WINNTEC Model #6020 LP REGULATOR

Bulletin Type:	RCL	Publication Date:	August 2021
Bulletin #(s):	21V-425 US 2021-367 Canadian	Make(s):	Jayco
Job Code(s):	9901567A - Inspection Only 9901567B - Inspection, Complete Replace, LP Leak Test	Model(s):	Various Models
Flat Rate(s):	9901567A - .10 hr 9901567B - .70 hr	Model Year(s):	2017-2021

Bulletin Type:	RCL
Bulletin #(s):	21V-430 US 2021-369 Canadian
Job Code(s):	9904567A – Inspection Only 9904567B – Inspection, Complete Replace, LP Leak Test
Flat Rate(s):	9904567A - .10 hr 9904567B - .70 hr

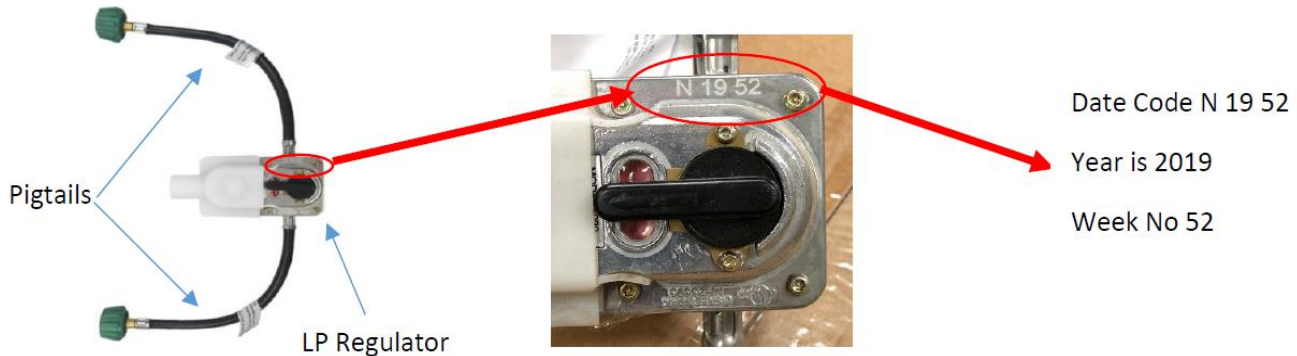
1. Only the Winntec Model #6020 - Dual Stage Double Cylinder - Automatic Changeover Regulator with Pigtails is affected. Replace the regulator and pigtails if the manufacturing date code stamped into the regulator is 2017, 2018 or 2019. Example shown below.

2. File a claim for inspection only if the unit does not have a Winntec model #6020 LP regulator or if the date code stamped into the regulator is not 2017, 2018, or 2019.
